CS - MPH PART B	
Scale	Project No.
Date	Issue Date
Drawn By	Drawing No.
Checked By	
Date Plotted

1 : 50  
19-102  
MT  
BS  
A3-49  
2023-04-18 4:30:25 PM

Roof Loading Area (South Elevation)

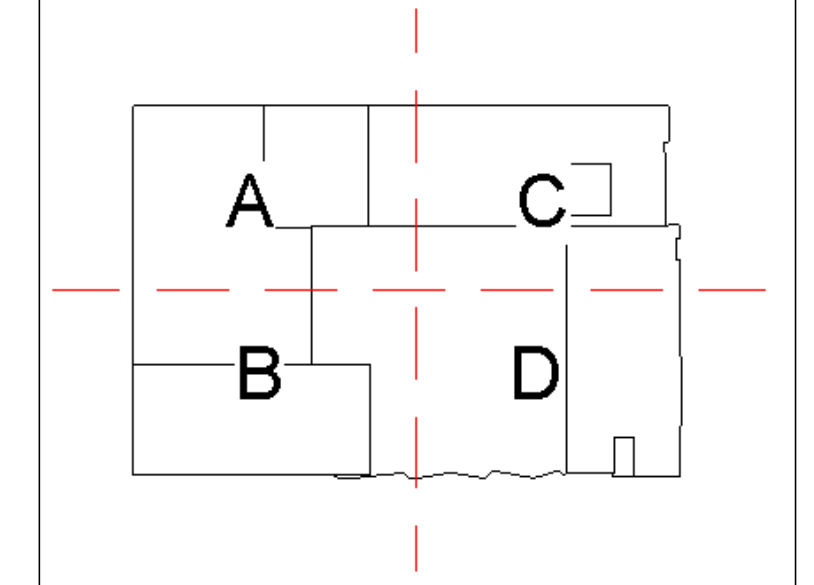
The new chiller will be craned to the mechanical penthouse roof loading area and moved through an overhead door (4500H x 3200W) into the mechanical room.
